REGIONAL REVIEW NOTIFICATION

ARC REVIEW CODE: R2105262

Name of Proposal: Sandtown Village DRI #3290

SANDTOWN VILLAGE DRI #3290 HUTCH DEVELOPMENT FULTON COUNTY, GEORGIA
CAMP CREEK PKWY AT CAMBELL TON RD
REZONING SITE PLAN

C1.1

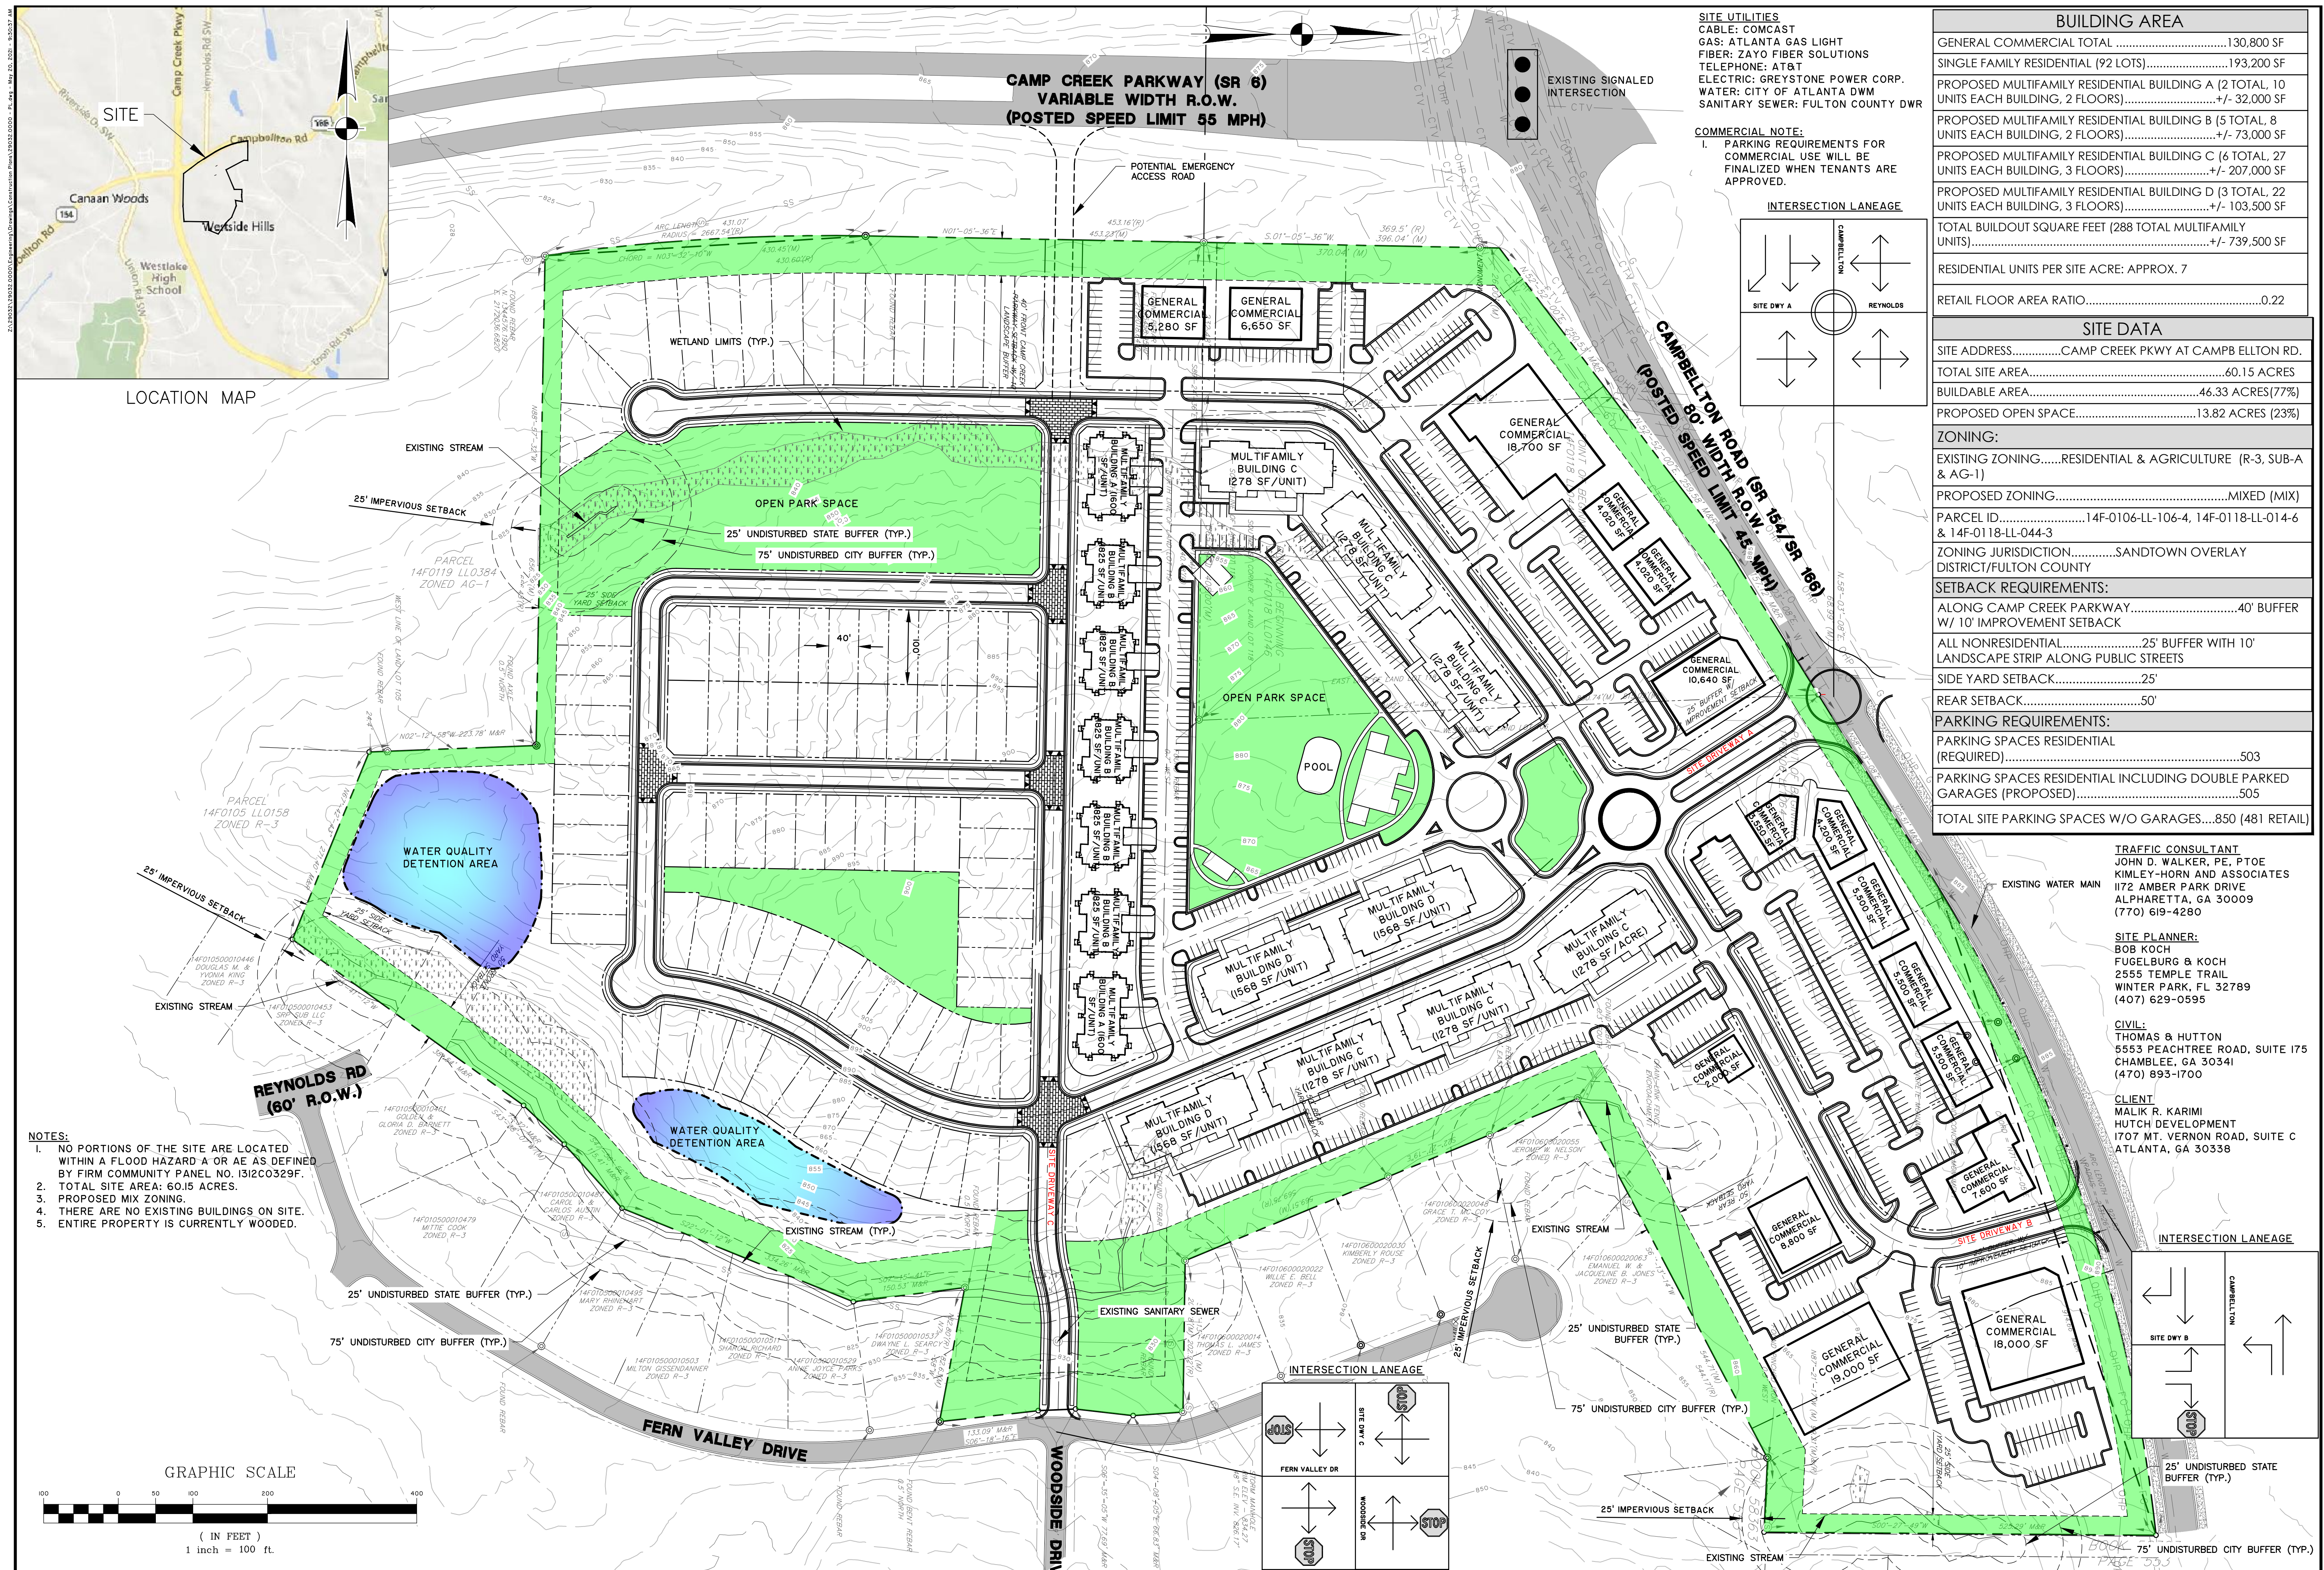
alternative mode. As presented, the site plan appears to show sidewalks on the internal streets, but no crosswalks at various locations are indicated. Both the central park space and the majority of the commercial uses are surrounded by surface parking without clear pedestrian pathways.

The project can further support The Atlanta Region's Plan in general by incorporating other aspects of regional policy, including green infrastructure and/or low-impact design (e.g., rain gardens, vegetated swales, etc.) in parking areas and site driveways, and as part of any improvements to site frontages. Please see the attached comments from ARC's Natural Resources Group, which note that this project is in the Camp Creek watershed and could become part of the Chattahoochee River large water supply watershed when proposed intakes for South Fulton and Coweta County are built downriver. They also note that there appear to be some intrusions from the multifamily parking onto the City's stream buffer and impervious setback that may require variances.

The USGS coverage for the project area shows an unnamed tributary to Camp Creek near the southeastern boundary of the project property. The submitted site plan shows this stream, as well as two other stream segments on the south side of the property and one on the west side of the property. All show a 75-foot undisturbed buffer and additional 25-foot impervious surface setback that is consistent with the city of South Fulton's Stream Buffer Ordinance. The State 25-foot Erosion and Sedimentation Act buffers area also shown. However, some intrusions into the City undisturbed buffer and impervious setback are shown, including some of the parking areas for the multi-family portion of the project. These intrusions may require a variance from the City. A stream crossing may require a variance from the State 25-foot Erosion and Sedimentation Act buffer Any unmapped streams on the property may also be subject to the City Stream Buffer Ordinance. Any unmapped waters of the State on the property may subject to the 25-foot state Erosion and Sedimentation Act buffers.

Based on the review of the site plan, a potential emergency access is referenced at Camp Creek Parkway/SR 6 and the adjacent side of the development.

There are no proposed bicycle improvements.
